**BREA 265 SPECIFIC PLAN**  
**JUNE 21, 2022 CITY COUNCIL QUESTIONS**

At the June 21, 2022 City Council meeting, a public hearing was held on the Brea 265 Specific Plan project ("Project"). At this meeting, the City Council provided various comments and raised questions regarding the Project. For the public's benefit, the Planning Division has prepared the following list of questions raised at the hearing and corresponding answers. For additional information, please contact the Planning Division at 714-990-7674 or at [planner@cityofbrea.net](mailto:planner@cityofbrea.net).

*\*Preliminary section drawings of Rose Drive in the City of Brea, adjacent to the Project is below:*

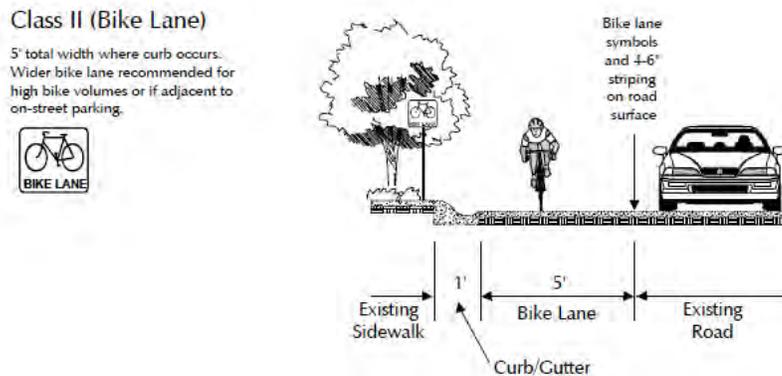
**Question:** Would Rose Drive be widened in Cities of Yorba Linda and Placentia to match the improvements required for the Project in the City of Brea?

**Answer:** *Both Cities of Yorba Linda and Placentia classifies Rose Drive as an arterial road, which has an ultimate built-out condition that will match the improvements required for the Project in the City of Brea, as follows:*

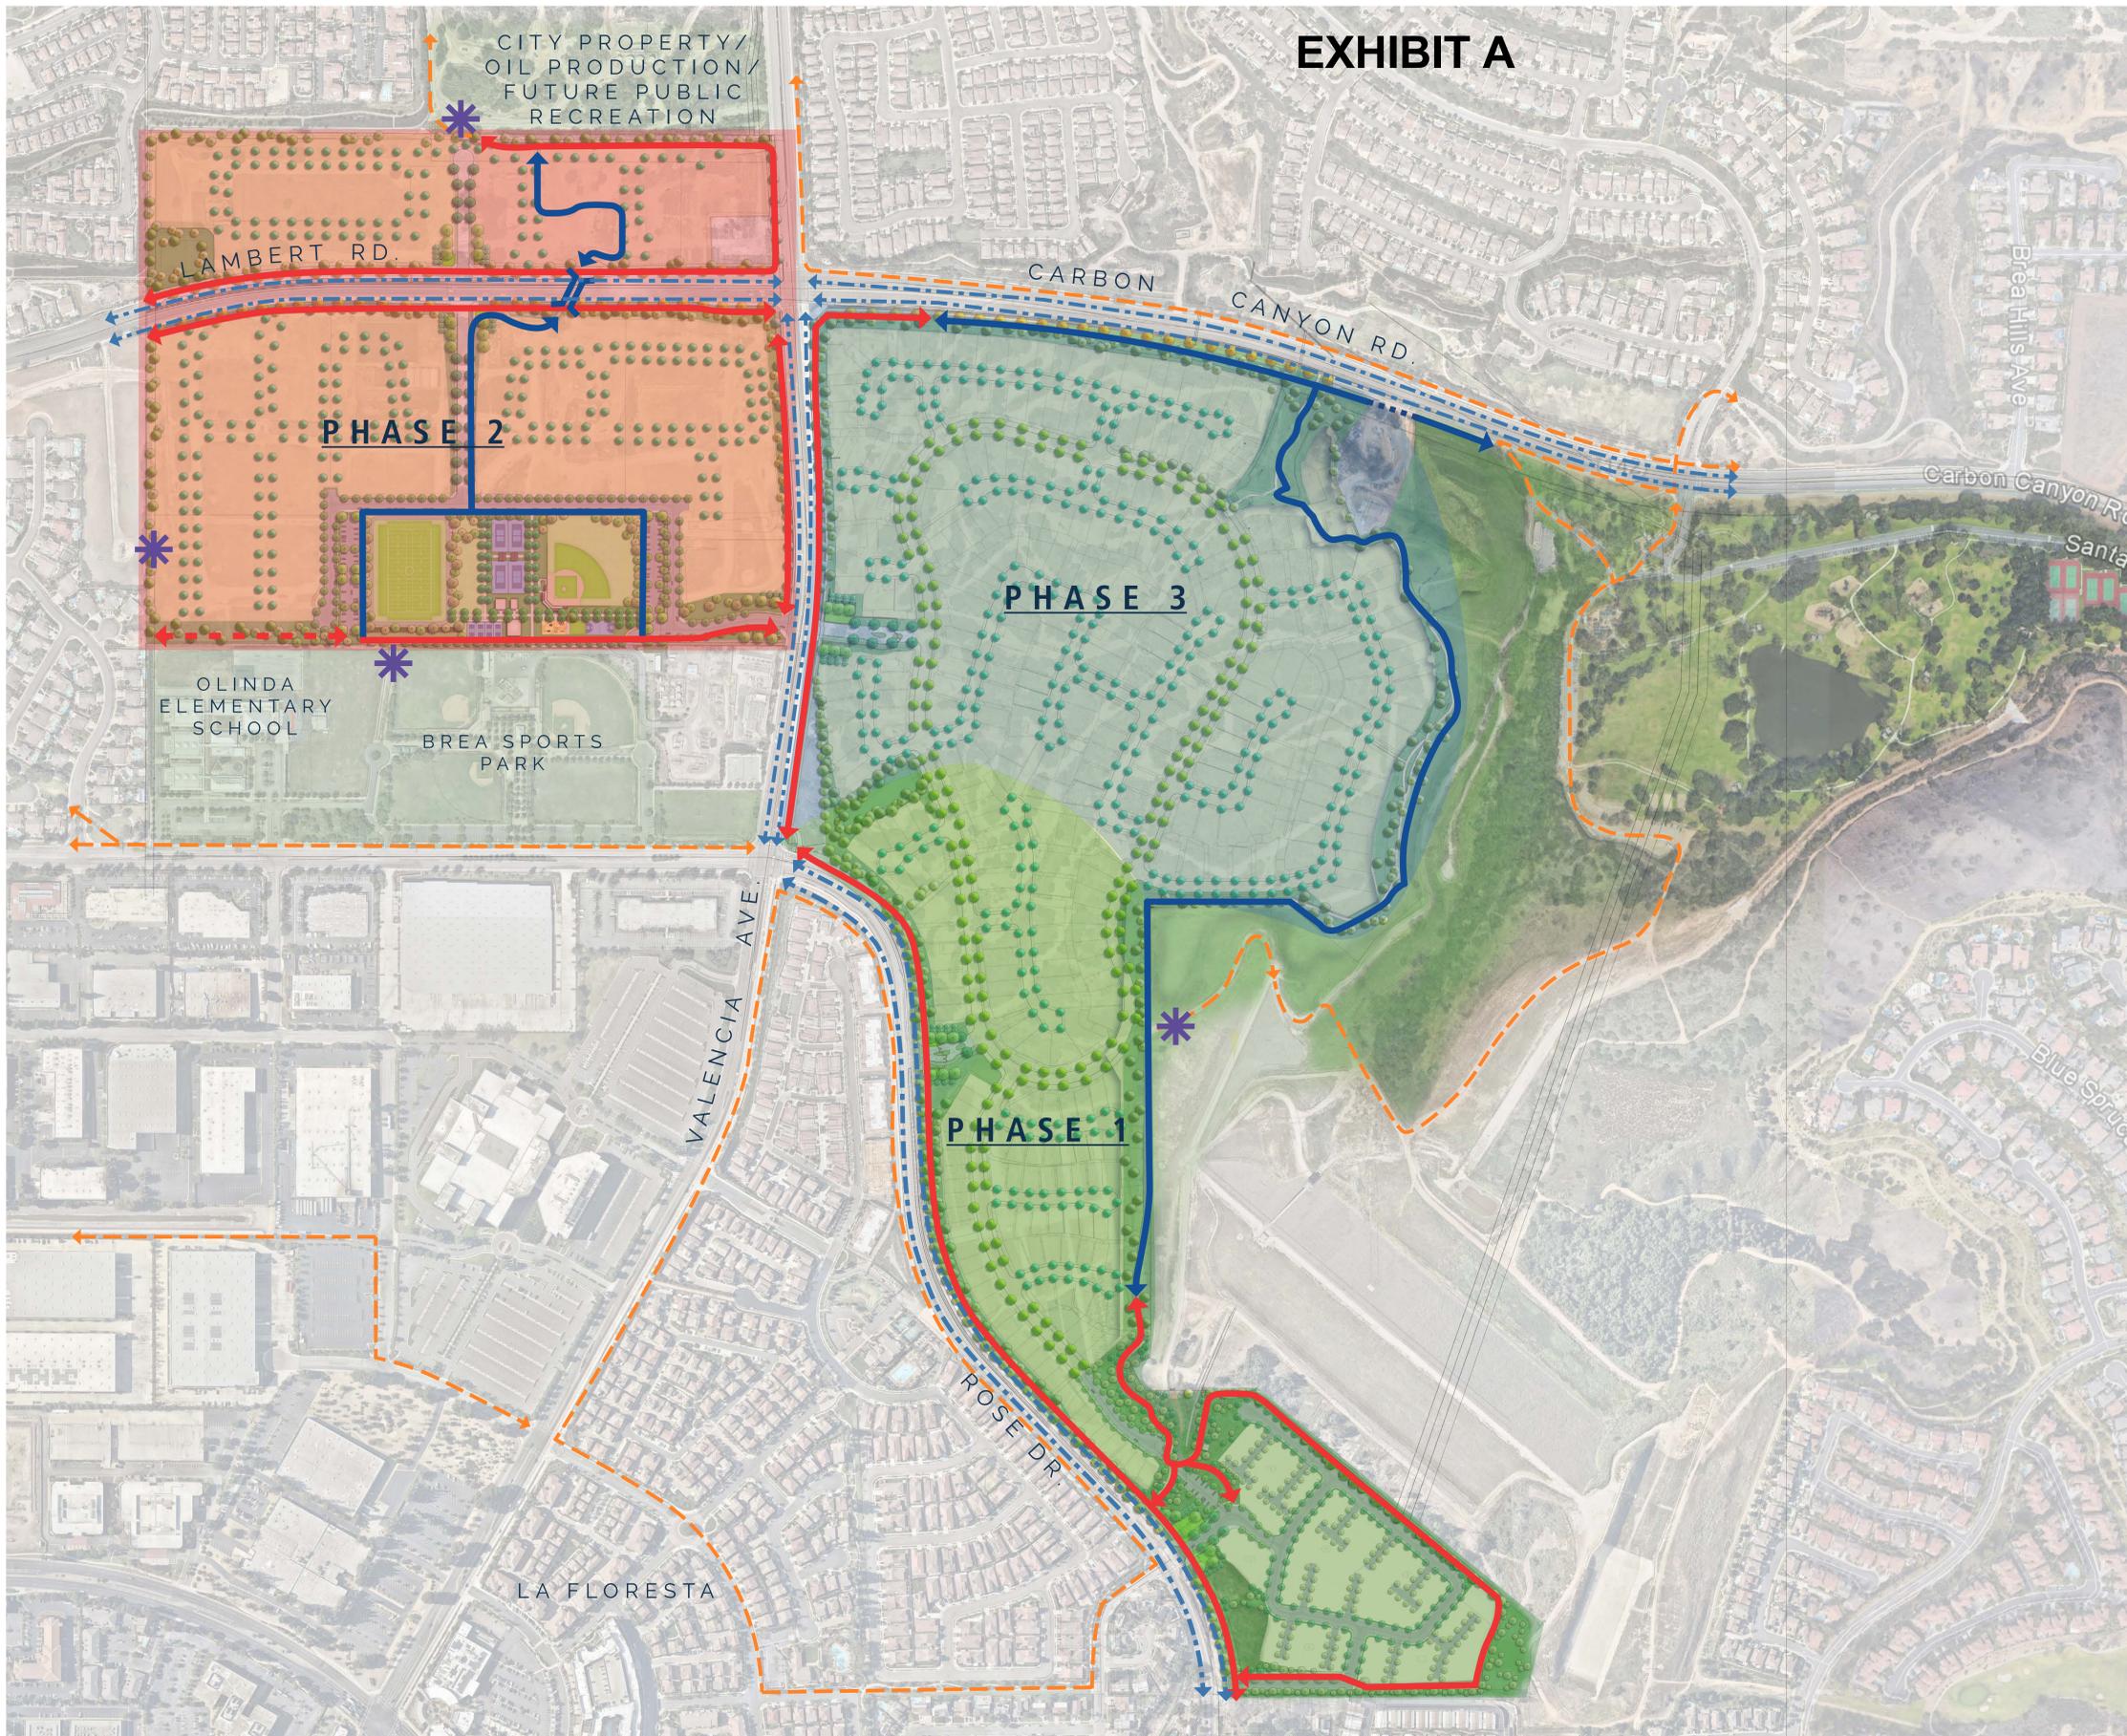
**Question:** Is the park design shown in the Project documents a final design?

**Answer:** *No, the park design shown in the Project document is to serve as an illustrative example only, and the applicant is required to obtain the City’s review and approval for the final design of the public park from all applicable City departments (i.e. Planning, Building, and Community Services). Also, as mentioned above, all artificial turf is required to obtain review and approval from the City’s Parks, Recreation and Human Services Commission.*
